Barela Development Group  
Albuquerque New Mexico  
Site Plan

- KEYED DRB CONDITIONS OF APPROVAL - 07 EPC 00573, JULY 19, 2007, SITE DEVELOPMENT PLAN FOR BUILDING PERMIT
- EPC DELEGATES FINAL SIGN OFF TO DRB
  - PRIOR TO SUBMITTAL APPLICANT SHALL MEET WITH STAFF PLANNER AND NEAR NORTH VALLEY NEIGHBORHOOD ASSOCIATION.

Site Development plan  
For Building Permit

PROJECT NUMBER: 1005513  
APPLICATION NUMBER: 07EPC-70242

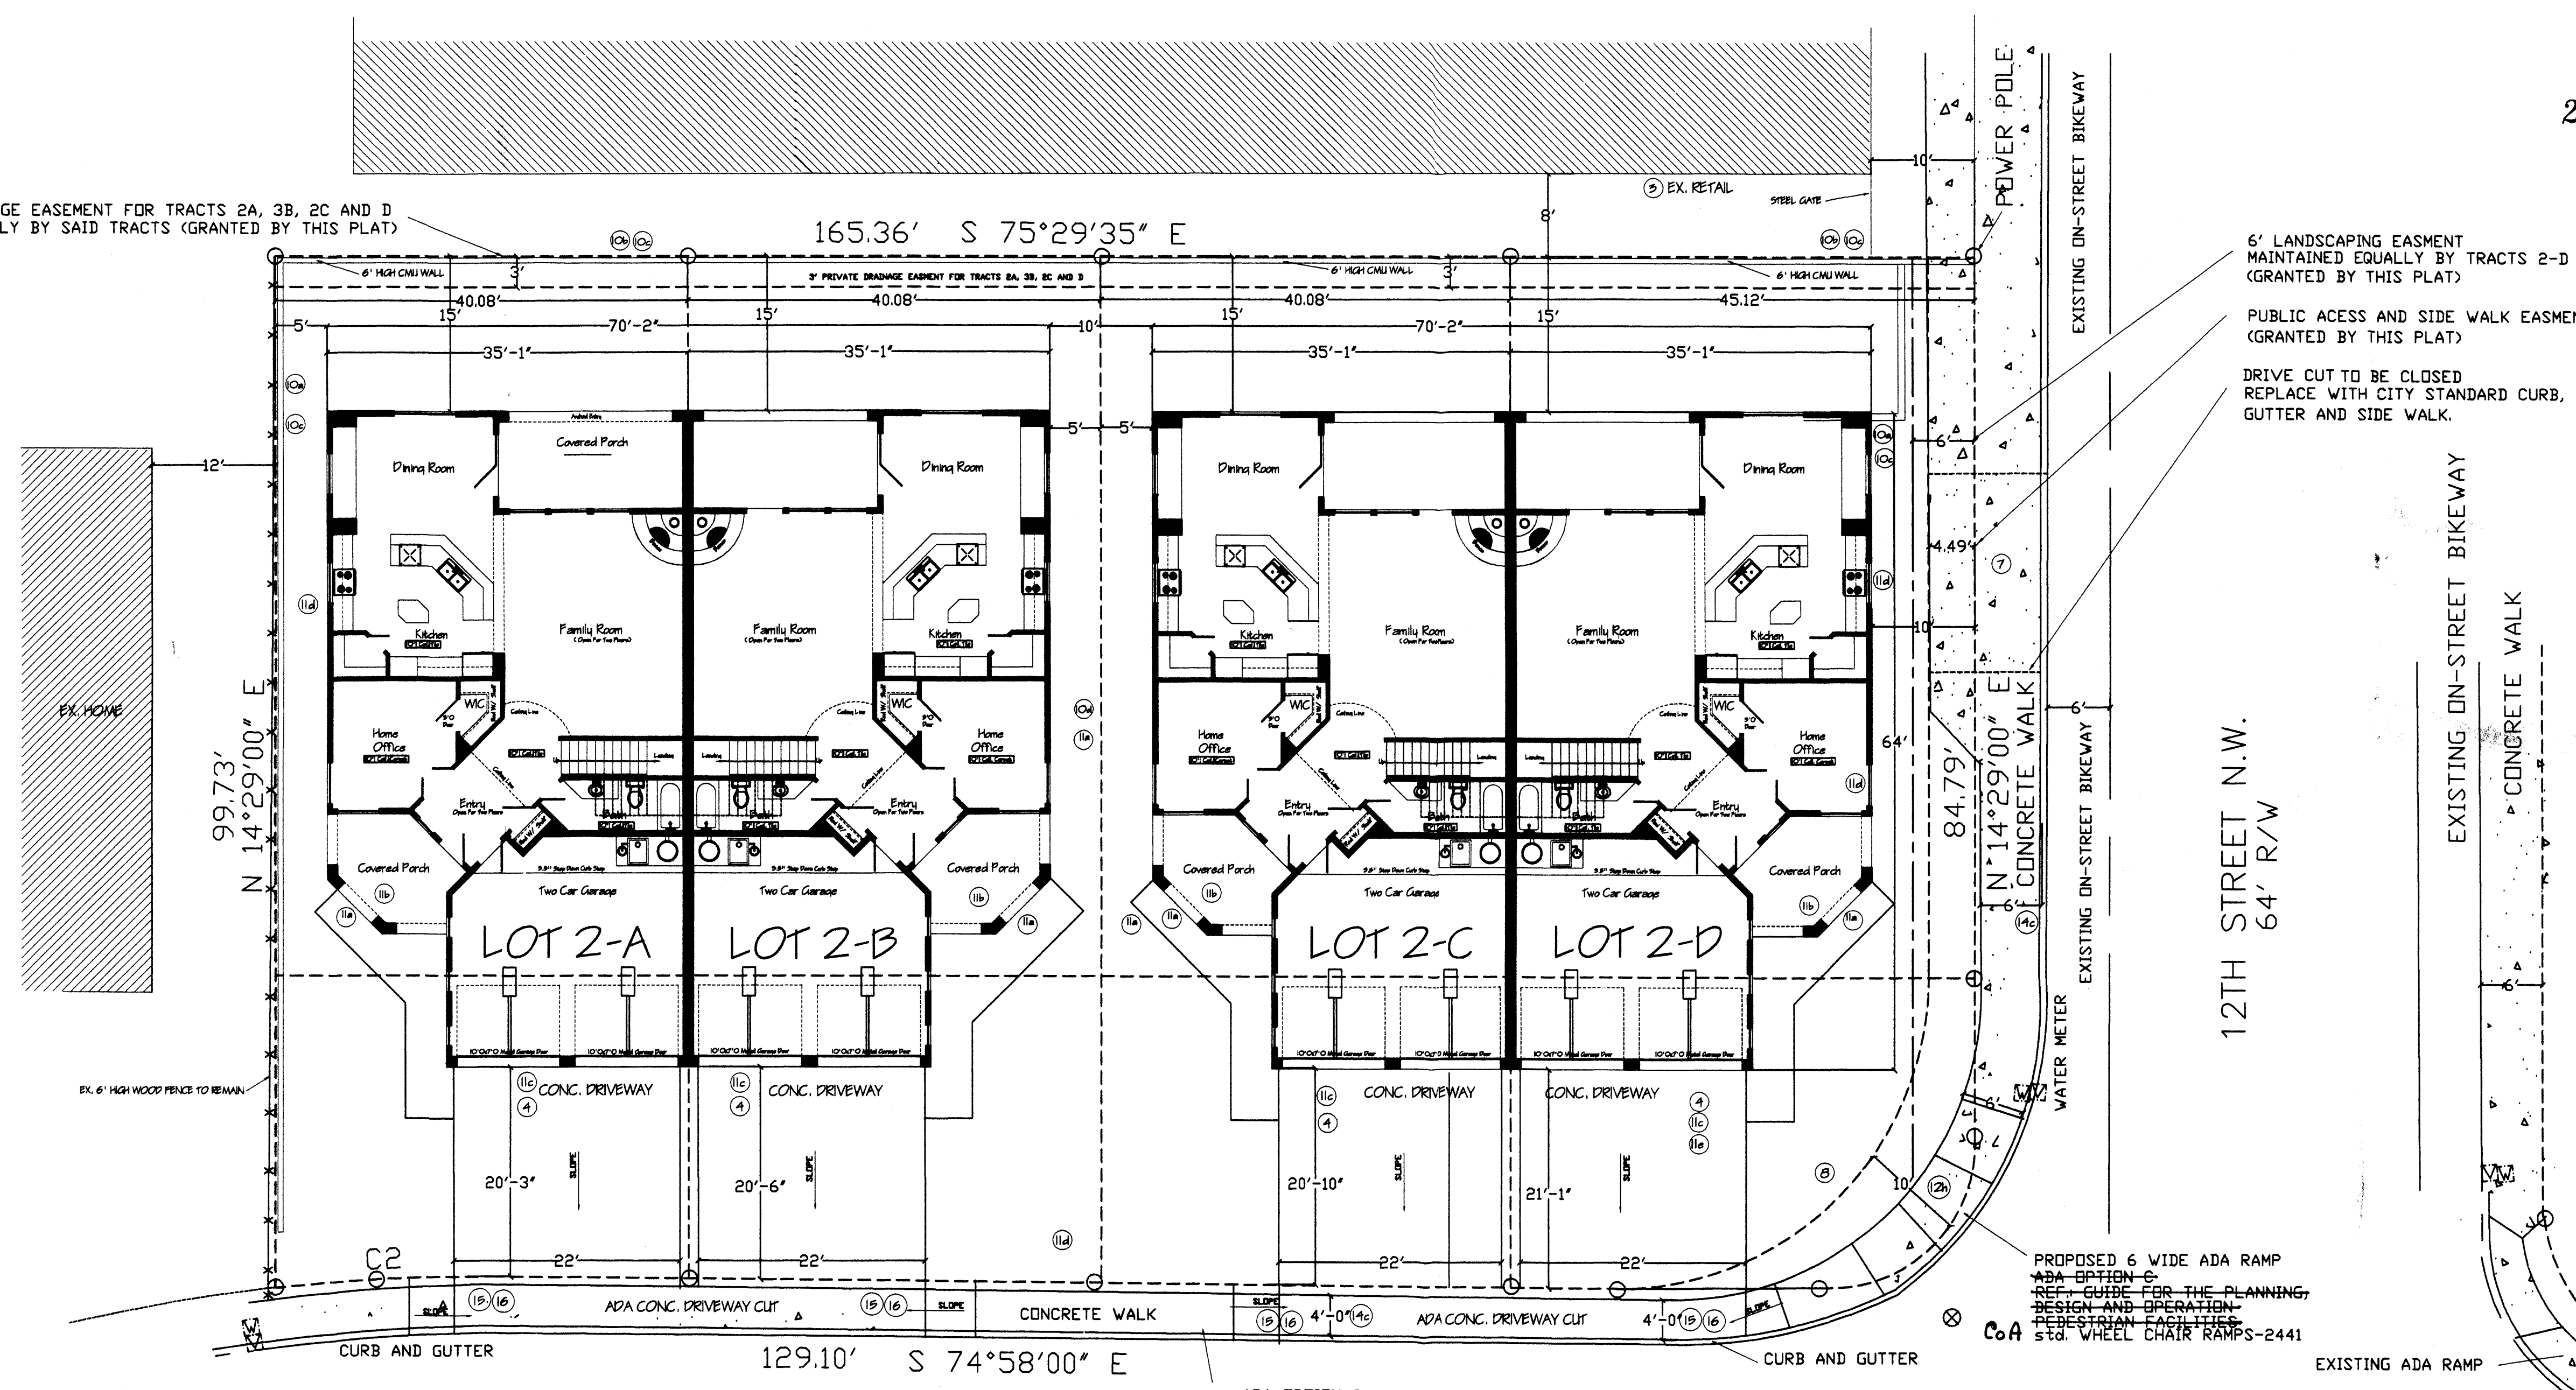
- EXISTING BUILDING TO THE NORTH SHOWN.
  - EACH DRIVE WAY SHALL BE A MIN OF 20' LONG TO COMPLY WITH ZONING CODE SETBACK FOR R-LT ZONE.
  - TYPOGRAPHICAL ERRORS CORRECTED.

- PARKING CALCULATIONS SHALL SHOW NUMBER OF BATHS PER UNIT.
  - THE EXISTING CURB CUT ON 12TH STREET SHALL BE CLOSED AND RESTORED TO CURB HEIGHT MATCHING SURROUNDING AREAS.

- GRADING, DRAINAGE AND UTILITY PLAN SHALL BE REVIEWED AND APPROVED BY APPROPRIATE AGENCIES BEFORE FINAL SIGN.
  - THE UPPER LEVEL OF EACH UNIT SHALL BE LIMITED TO 90% OF THE BUILDING FOOTPRINT AND SHALL BE STEPPED BACK FROM DON FRANCISCO.

- LANDSCAPING
- REMOVED NOTE: "FINAL LANDSCAPING LAYOUT AND DESIGN TO BE DETERMINED UPON RECEIPT OF FINAL GRADING PLAN." see sheet 2
  - A SHRUB PLANTING DETAIL IS PROVIDED. see sheet 2

- ALL GROUND COVER SHALL BE INDICATED. see sheet 2
  - THE AMOUNT OF HIGH WATER TURF SHALL BE REDUCED. see sheet 2
  - THE APPLICANT SHALL CORRECT PLANT COUNTS FOR OCOTILLO. see sheet 2

- EXISTING CITY MAINTAINED LANDSCAPING TO THE NORTH OF THE CURB CUT ON 12TH STREET SHALL BE DESIGNED TO MATCH THE EXISTING CITY LANDS TO THE NORTH. see sheet 2

- THE APPLICANT SHALL REPAIR DAMAGE DONE TO CITY-INSTALLED LANDSCAPING ADJACENT TO TO OR ON THE SUBJECT SITE TO MATCH THE LANDSCAPE PLANS FOR THE LOS CANCELARAS VILLAGE CENTER STREETSCAPE IMPROVEMENT. THE APPLICANT SHALL COORDINATE WITH THE METROPOLITAN REDEVELOPMENT AGENCY TO ENSURE THAT THIS CONDITION IS MET. see sheet 2

- THE PLANTING AREA SOUTH AND EAST OF THE POINTS CURVATURE AT THE SOUTHEAST CORNER SHALL BE REPLACED WITH SIDEWALK TO MATCH EXISTING SIDEWALKS ALONG 12TH STREET IN MATERIALS, COLOR, STYLE. WILDFLOWERS SHOWN IN THE LANDSCAPE PLAN SHALL BE RELOCATED WITHIN THE SITE. SHEETS 1 AND 2

- THE APPLICANT SHALL COMPLY WITH ALL WASTE MANAGEMENT DEPARTMENT ORDINANCES AND REQUIREMENTS.
- DESIGN
- FRONT COURTYARD WALLS SHALL BE REMOVED FROM THE SITE PLAN.

- TURRETS SHALL BE REMOVED FROM PLAN.
  - DOORS FOR THE TWO-CAR GARAGES SHALL BE PROVIDED IN THE FORM OF TWO SEPARATE SINGLE DOORS.
  - ADDITIONAL ARTICULATION TO INCLUDE WINDOWS SHALL BE PROVIDED ON THE EAST ELEVATION OF LOT A AND THE WEST ELEVATION ON LOT D.

- BUILDING SHALL BE DESIGNED IN TERRITORIAL STYLE.

- CITY ENGINEER CONDITIONS
- THE DEVELOPER IS RESPONSIBLE FOR PERMANENT IMPROVEMENTS TO THE FACILITIES ADJACENT TO THE PROPOSED SITE DEVELOPMENT PLAN. THOSE IMPROVEMENTS WILL INCLUDE ANY ADDITIONAL RIGHT-OF-WAY REQUIREMENTS, PAVING, CURB AND GUTTER, SIDEWALK AND ADA ACCESSIBLE RAMPS THAT HAVE NOT ALREADY BEEN PROVIDED FOR. ALL PUBLIC INFRASTRUCTURE CONSTRUCTED WITHIN THE PUBLIC RIGHT-OF-WAY OR PUBLIC EASEMENTS SHALL BE TO CITY STANDARDS. THOSE STANDARDS WILL INCLUDE BUT ARE NOT LIMITED TO SIDEWALKS (std. dwn. 2450) DRIVEWAYS (std. dwn. 2425), PRIVATE ENTRANCES (std. dwn. 2426) AND WHEEL CHAIR (std. dwn. 2441).

- PROVIDE PARKING CALCULATIONS.
  - SHOW SIDEWALK (4' ON DON FRANCISCO AND 6' ON 12TH STREET) AND LANDSCAPE BUFFER ON SITE PLAN. SIDEWALKS TO BE LOCATED AT PROPERTY LINE CITY RIGHT-OF-WAY.

- SITE PLAN SHALL COMPLY AND BE DESIGNED PER DPM STANDARDS.
  - PLATTING MUST BE CONCURRENT DRB ACTION.
  - SIDEWALK TRANSITIONS AT THE DRIVE PADS ON DON FRANCISCO SHALL BE CONSTRUCTED TO 12:1 RATIO TO MAINTAIN ADA ACCESSIBILITY.

- SIDEWALK ALONG DON FRANCISCO SHALL NOT EXCEED A 2% CROSS SLOPE.

DRIVE CUT TO BE CLOSED REPLACE WITH CITY STANDARD CURB, GUTTER AND SIDE WALK.

3621 12TH STREET NW ZONE: SU-1/ R-LT USES ZONE ATLAS: G4
LEGAL DESCRIPTION OF TRACT 2 LANDS OF ALBERT L. MATTHEW ALBUQUERQUE, BERNALILLO COUNTY, NEW MEXICO FEBRUARY, 2007
FRONT AND EAST SIDE SETBACK - 10' REAR SETBACK - 15' WEST SETBACK - 5'
SQUARE FOOTAGE 1ST AND 2ND FLOORS TOTAL LOT A - 4,068 SQ FT 1ST FL - 2261 sq ft 2ND FL - 1076 sq ft LOT B - 4,068 SQ FT 1ST FL - 2261 sq ft 2ND FL - 1076 sq ft LOT C - 4,068 SQ FT 1ST FL - 2261 sq ft 2ND FL - 1076 sq ft LOT D - 4,960 SQ FT 1ST FL - 2261 sq ft 2ND FL - 1076 sq ft
PARKING CALCULATIONS 2 BATH ROOMS PER TOWNHOUSE 2 ON SITE PARKING 5 PER RESIDENCE 8 PARKING 5 TOTAL ON SITE LOT A - 2 BATHS LOT B - 2 BATHS LOT C - 2 BATHS LOT D - 2 BATHS
